mk1 C920 PCBA wiring

New C920 wiring

Recently updated C920 webcam version was released featuring new PCB. These changes introduced two unexpected issues: wiring is different and new PCB has mechanical interference with aluminium rework kit back plate.

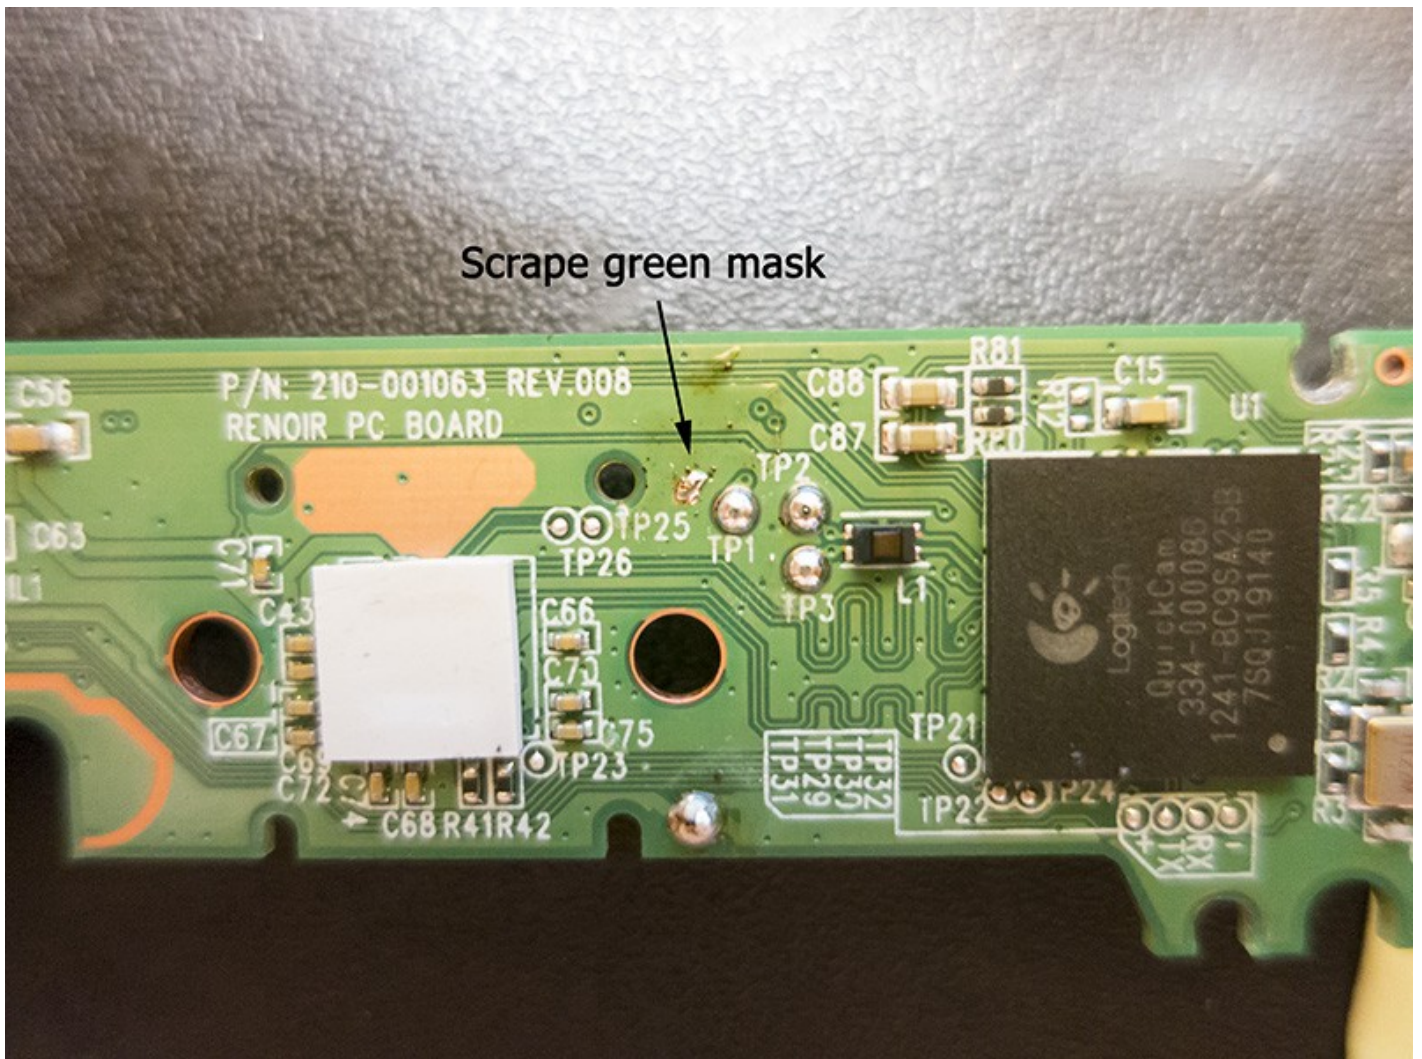
If you rework webcam by yourself, please use pin-out diagram as pictured below to solder wires.

Test point	Signal
TP24	VCC
TP26	USB D+
TP25	USB D-

green soldering mask with scalpel to access GND.
